Access Compliance Report Public Rights-of-Way (Curb Ramps)

Main Street: HEATHCLIFF_DR Cross Street: LA_LOMA_DR Location: E

ADA ID: RPRK220107113129 Ramp Type: Type 4 - Parallel Initial Pass/Fail: Fail Overall Compliance: No Severity Score: 16

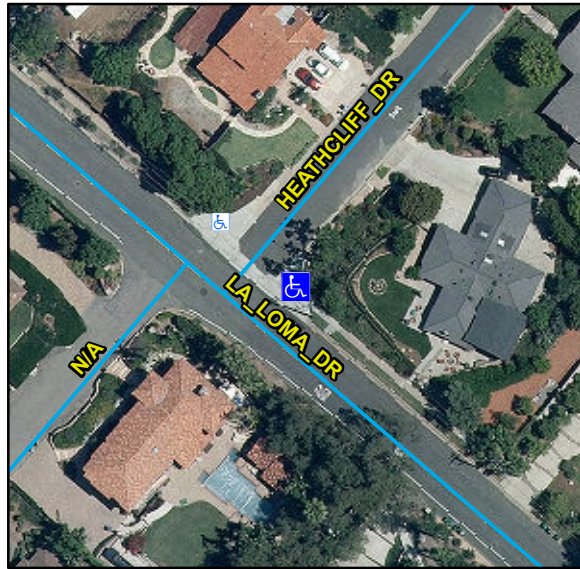
Compliance	Description	Data	Compliance	Description	Data
N/A	Ramp Length LT (in)	111	N/A	Ramp Length RT (in)	117
Yes	Ramp Width LT (in)	82	Yes	Ramp Width RT (in)	94
Yes	Ramp Run Slope LT (%)	2.3	No	Ramp Run Slope RT (%)	11.8
No	Ramp Cross Slope LT (%)	2.2	Yes	Ramp Cross Slope RT (%)	0.1
N/A	Landing Present	N/A	N/A	DWS Provided	N/A
N/A	Landing Length (in)	N/A	N/A	DWS Contrast	N/A
N/A	Landing Width (in)	N/A	N/A	DWS Length (in)	N/A
N/A	Landing Run Slope (%)	N/A	N/A	DWS Full Width	N/A
N/A	Landing Cross Slope (%)	N/A		DWS Offset Type	N/A
N/A	Landing Movement Obstructed?	N/A	N/A	DWS Offset Left (in)	N/A
	Landing Movement Type	N/A	N/A	DWS Offset Right (in)	N/A
N/A	Landing Shared	N/A			
N/A	Clear Space	Yes			
N/A	Clear Space To Crosswalk (in)	N/A			
N/A	Marked Crosswalk 1	No	N/A	Marked Crosswalk 2	No
	Crossing 1 Direction	NW		Crossing 2 Direction	SW
N/A	Marked Crosswalk 1 Width (in)	N/A		Marked Crosswalk 2 Width (in)	N/A

Remove & Replace Curb Ramp With Two New Directional Ramps or Equivalent.

R304.5.3, R304.3.2, STD 1115
